Planning Alterations (A.1.)

INDUSTRIAL DEVELOPMENT AT TAY LANE, GREENOGUE RATHCOOLE, Co. DUBLIN

ELECTRICAL WASTE MANAGEMENT LTD

D1541 D3 PL3

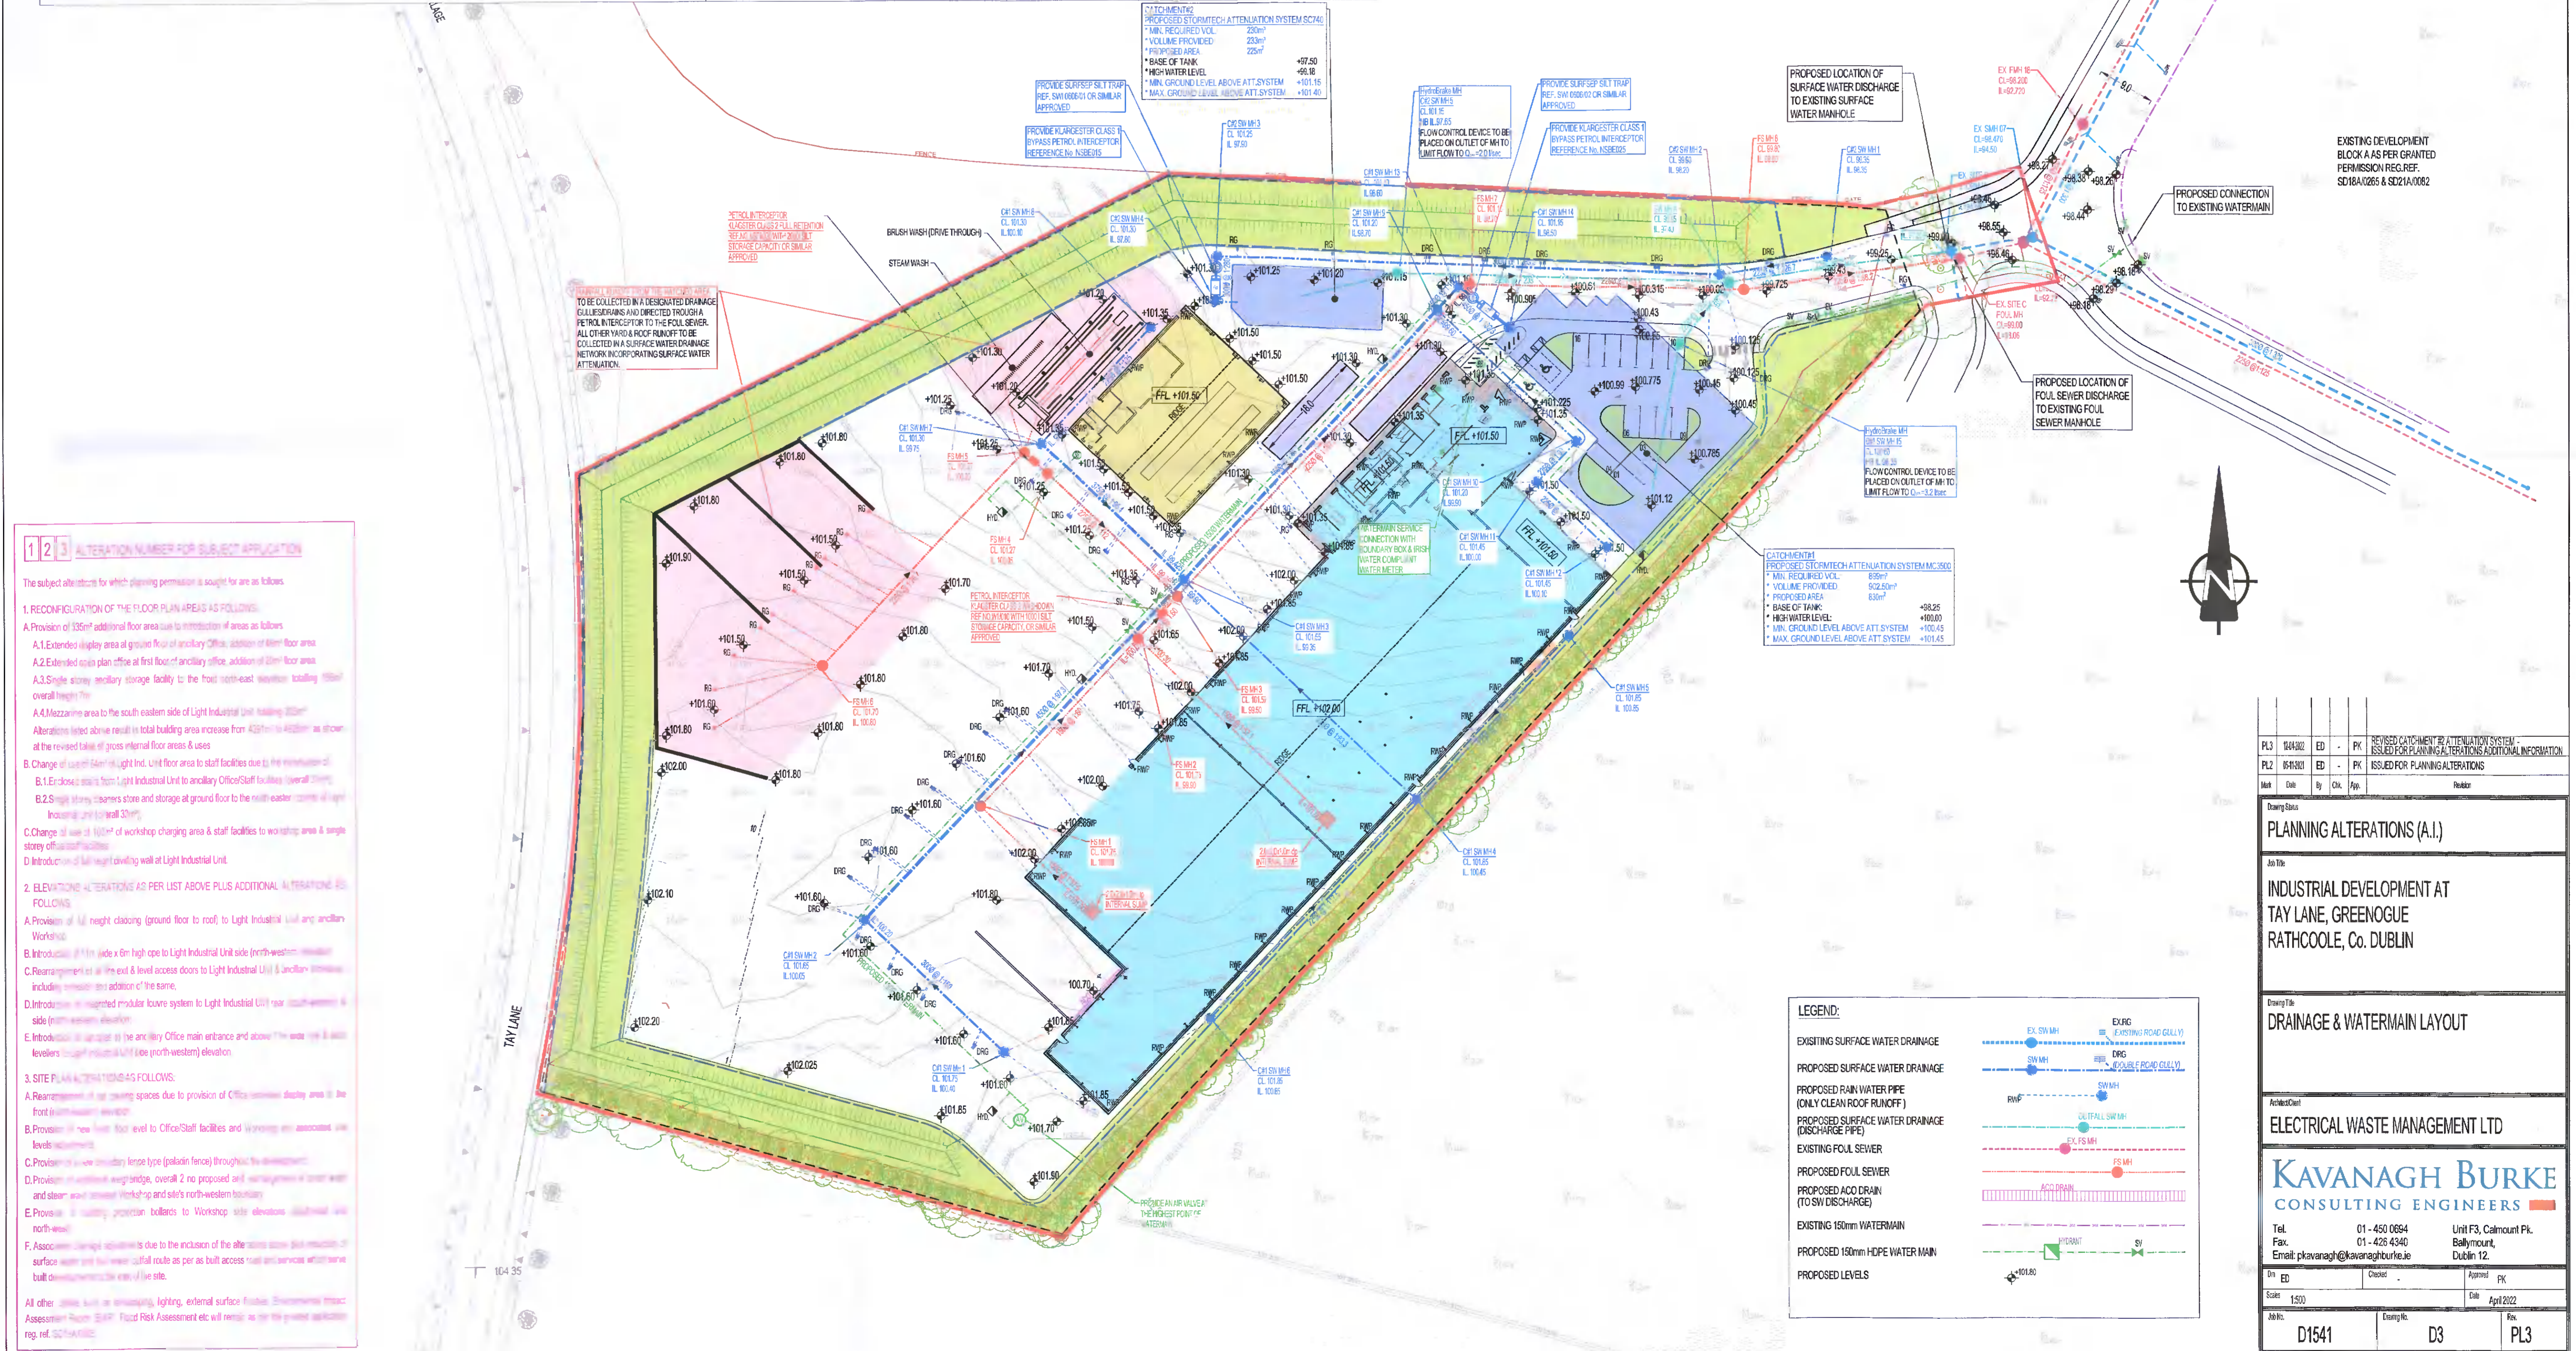
- 1 2 3 ALTERATION NUMBER FOR SUBJECT APPLICATION**
- The subject alterations for which planning permission is sought for are as follows:
1. RECONFIGURATION OF THE FLOOR PLAN AREAS AS FOLLOWS:

- A. Provision of 132m² additional floor area due to introduction of areas as follows:
 - A.1. Extended display area at ground floor of ancillary office, addition of 40m² floor area

- A.2. Extended main plan office at first floor of ancillary office, addition of 20m² floor area
 - A.3. Single storey secondary storage facility to the front north-east elevation totaling 150m² overall height 7m

- A.4. Mezzanine area to the south eastern side of Light Industrial Unit, totaling 200m²
 Alterations listed above result in total building area increase from 432m² to 4552m² as shown at the revised table of gross internal floor areas & uses

- B. Change of use of 40m² of Light Ind. Unit floor area to staff facilities due to the introduction of:
 - B.1. Enclosed stairs from Light Industrial Unit to ancillary Office/Staff facilities (overall 200m²)

- B.2. Single storey cleaners store and storage at ground floor to the north eastern corner of Light Industrial Unit (overall 30m²)
 - C. Change of use of 100m² of workshop charging area & staff facilities to workshop area & single storey office/assistant facilities

- D. Introduction of full height loading dock at Light Industrial Unit
 2. ELEVATION ALTERATIONS AS PER LIST ABOVE PLUS ADDITIONAL ALTERATIONS AS FOLLOWS:

- A. Provision of full height loading dock (ground floor to roof) to Light Industrial Unit and ancillary Workshop
 - B. Introduction of 11m wide x 6m high open to Light Industrial Unit side (north-western elevation)

- C. Reorganisation of the end & level access doors to Light Industrial Unit & ancillary Workshop, including removal and addition of the same
 - D. Introduction of suggested modular lounge system to Light Industrial Unit (see south-western & side (from eastern elevation)

- E. Introduction of ramp to the ancillary Office main entrance and above the side view & side levelers to Light Industrial Unit (see north-western elevation)

3. SITE PLAN ALTERATIONS AS FOLLOWS:
 - A. Reorganisation of car parking spaces due to provision of Office/assistant display area in the front (north-western elevation)

- B. Provision of new level floor level to Office/Staff facilities and Workshop with associated use levels reductions
 - C. Provision of new secondary fence type (pallisade fence) throughout the development

- D. Provision of additional landscaping, overall 2 no proposed and 2 no proposed at front west and rear west (overall workshop and site's north-western boundary)

- E. Provision of quality position bollards to Workshop site elevations (situated west north-west)
 - F. Associated drainage alterations due to the inclusion of the alterations above (see details of surface water and foul water outfall route as per as built access from services entrance built development on the east of the site.
